Access Compliance Report

Public Rights-of-Way

(Curb Ramps)

Intersection ID: 19457	Main Street: S_TRYON_ST	Cross Street: YORKDALE_DR	Location: SE
ADA ID: 150A2E392043	Ramp Type: PerpDiag	Initial Pass/Fail: Fail	Overall Compliance: No
			Severity Score: 13.75

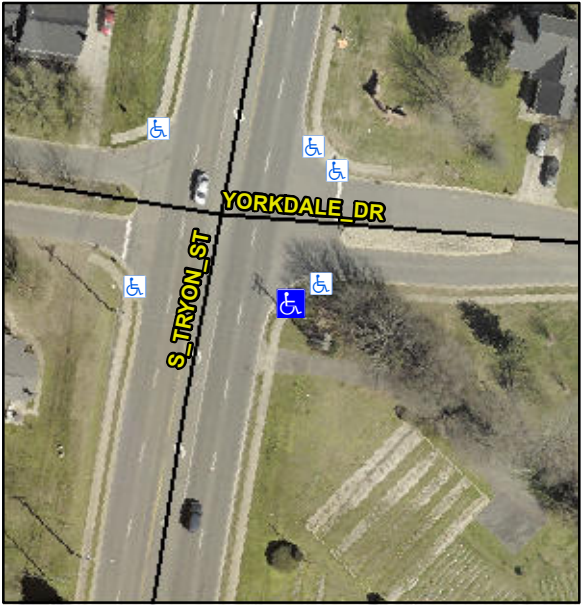
Codes/Mitigation Info/Possible Solution			Field Measurements/Component Compliance		
	Possible Solutions:		Compliance	Description	Data
	Remove & Replace Curb Ramp With Two New Directional Ramps or Equivalent.		N/A	Ramp Length (in)	80.0
			Yes	Ramp Width (in)	48.0
			N/A	Flare Type LT	N/A
			N/A	Flare Slope LT (%)	N/A
			N/A	Flare Traversable LT?	N/A
			N/A	Landing Length (in)	N/A
			N/A	Landing Width (in)	N/A
			N/A	Landing Slope (%)	N/A
			N/A	Landing X Slope (%)	N/A
<p>Surveyor Notes:</p> <p>N/A</p> <p>PROW/ADA:</p> <p>R304.2.2, R304.5.3</p>			N/A	Flare Type RT	N/A
			N/A	Flare Slope RT (%)	N/A
			N/A	Flare Traversable RT?	N/A
			N/A	DWS Provided?	N/A
			N/A	DWS Contrast?	N/A
			N/A	DWS Length (in)	N/A
			N/A	DWS Full Width?	N/A
			N/A	DWS Offset (in)	N/A
			N/A	Gutter Ponding?	N/A
			N/A	Gutter Lip Ht (in)	N/A
<p>Total Cost:</p> <p>\$ 3200.00</p>			N/A	Painted X Walk1?	No
			N/A	X Walk 1 Direction	To N
			N/A	X Walk 1 Width (in)	N/A

N/A	X Walk 1 Slope (%)	3.1
			N/A	X Walk 1 X Slope (%)	6.0
			N/A	Ramp inside XWalk1?	N/A
			N/A	Road Slope (%)	1.9
			N/A	Road X Slope (%)	5.2
			N/A	Any Obstructions?	N/A
			N/A	Obstruction Type	
			N/A	Clear Space?	N/A
			N/A	Clear Space to XWalk (in)	N/A
			N/A	Storm Grate/Utility Hazard?	N/A
			N/A	Storm Grate/Utility Type	
			N/A		N/A
			Yes	Surface Condition? (G/P)	Good
